**AGENDA**  
**Molalla Planning Commission**  
**6:30 PM, July 6, 2022**

- SDR04-2022 – 710 W Main ST – New Fueling Station and Convenience Store

<b>Date:</b>	June 29, 2022 for the July 6, 2022 Planning Commission Meeting
<b>File No.:</b>	Consolidated Review for SDR04-2022 and CUP02-2022
<b>Proposal:</b>	Construction of a New Fueling Station and Convenience Store
<b>Address:</b>	710 W Main ST (OR-211)
<b>Tax Lot:</b>	Taxlots 300 and 390 of Clackamas County Taxmap 52E08C
<b>Applicant:</b>	AKS Engineering and Forestry on behalf of Molalla Petroleum – Zach Pelz 3700 River RD N, STE 1 Keizer, Oregon 97303
<b>Property Owners:</b>	Donald Gary Bunnell and Marie Anne Bunnell, and successors, as Trustees of the Bunnell Family Trust 8751 Redcliff Place Riverside CA, 92508
<b>Applicable Standards:</b>	<b>Applicable Standards: Molalla Municipal Code, Title 17, Development Code</b>

**NORTH ELEVATION**  
SCALE: 1/4" = 1'-0"

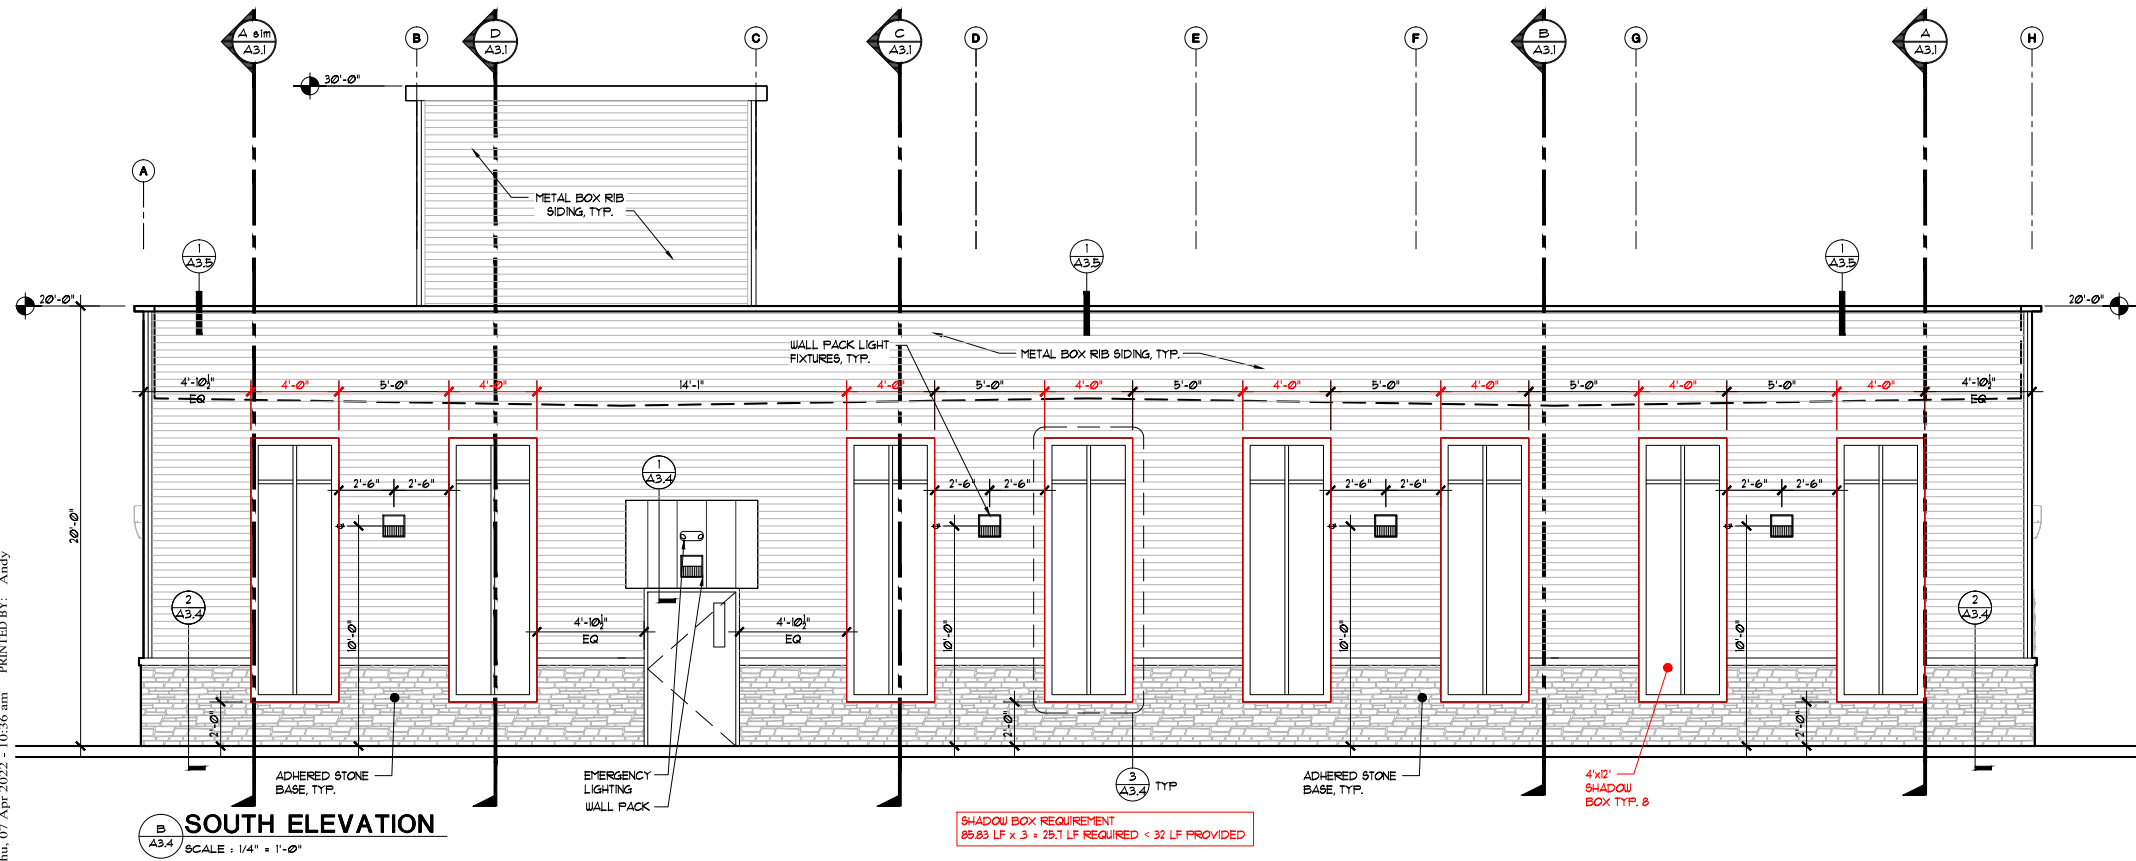
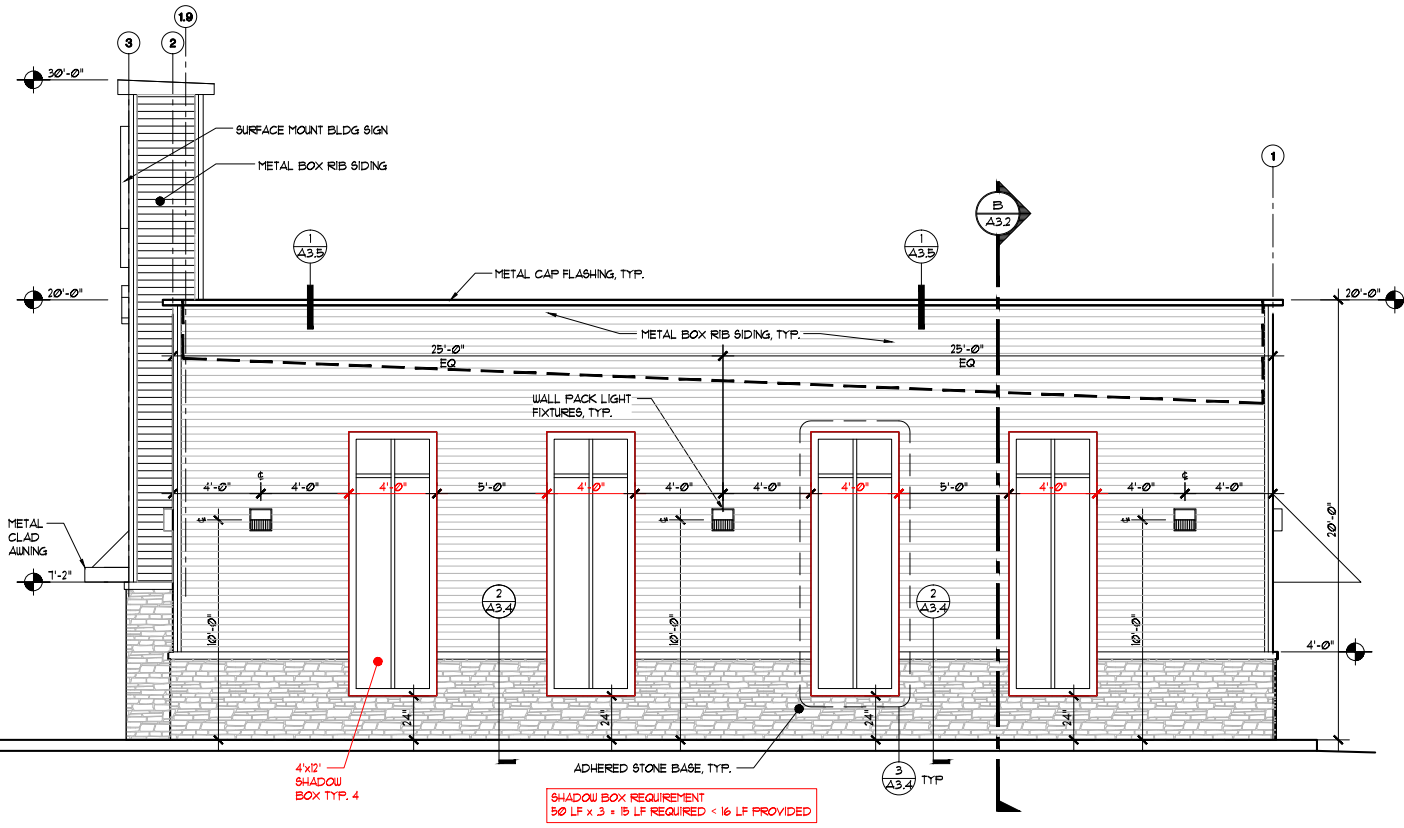
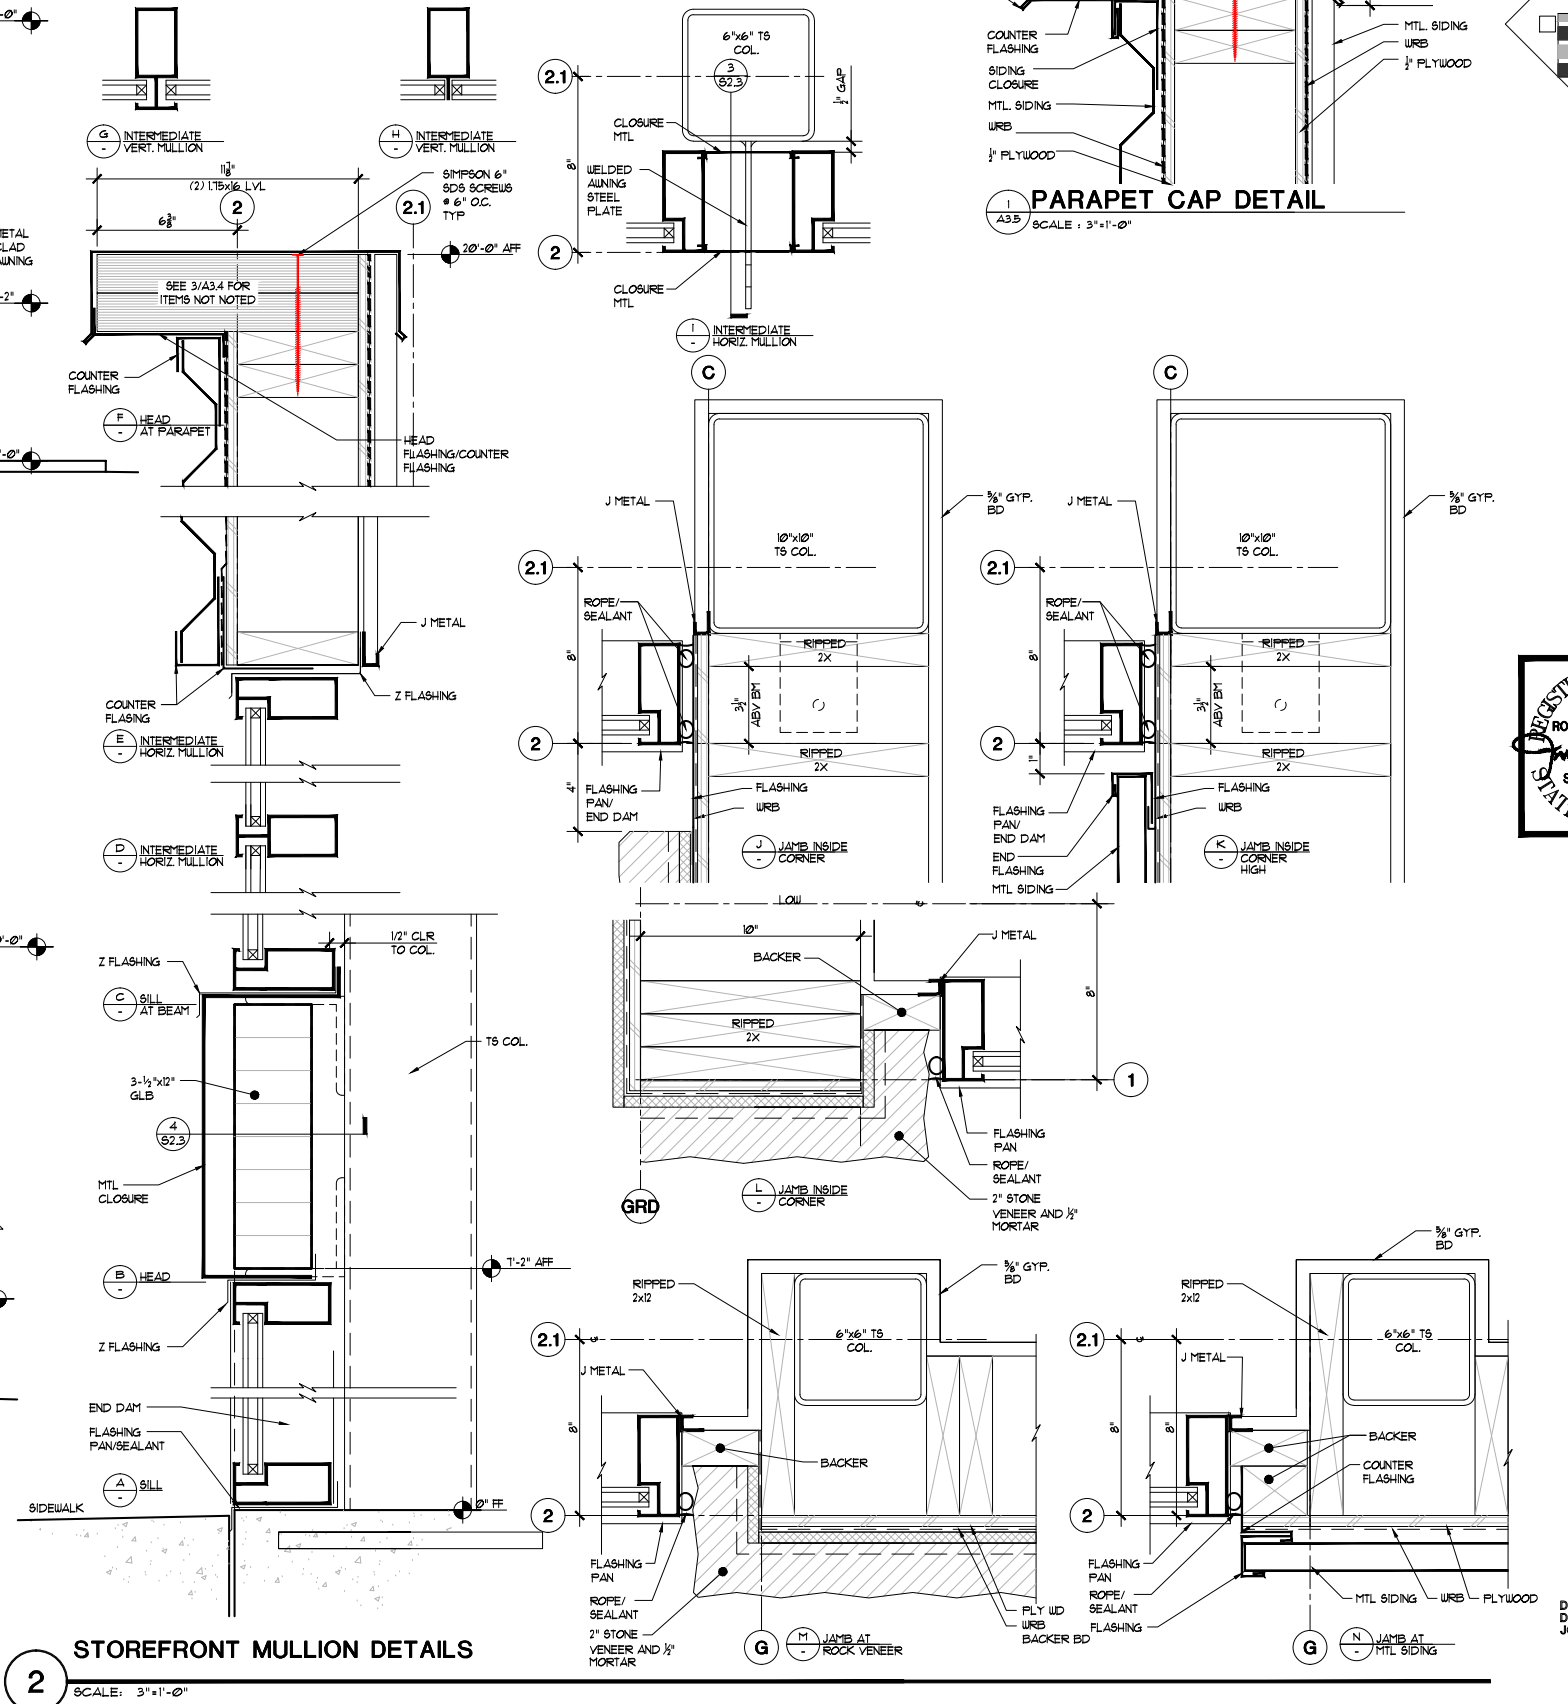
**Findings:** The Applicant has not proposed windows on the western, eastern, and southern facades of the proposed building stating that these interior walls will be "lined with storage, coolers, bathrooms, utilities, and kitchens that make compliance with the transparency standards impractical." The Applicant has proposed shadow boxes instead that provide similar detailing to exterior window designs."

**Findings:** The Applicant’s submitted architectural plans show canopies and pillars on the north facing façade that provide the required depth for breaks. Other facades are not street facing and these standards do not apply to them. These standards are met.

**Findings:** The Applicant’s submitted architectural plans use change of materials from stonewall base to metal siding to a short but distinct black top. These materials extend around the building, excepting where windows are utilized to define the bottom portion of the building along the street facing northern frontage. This standard is met.
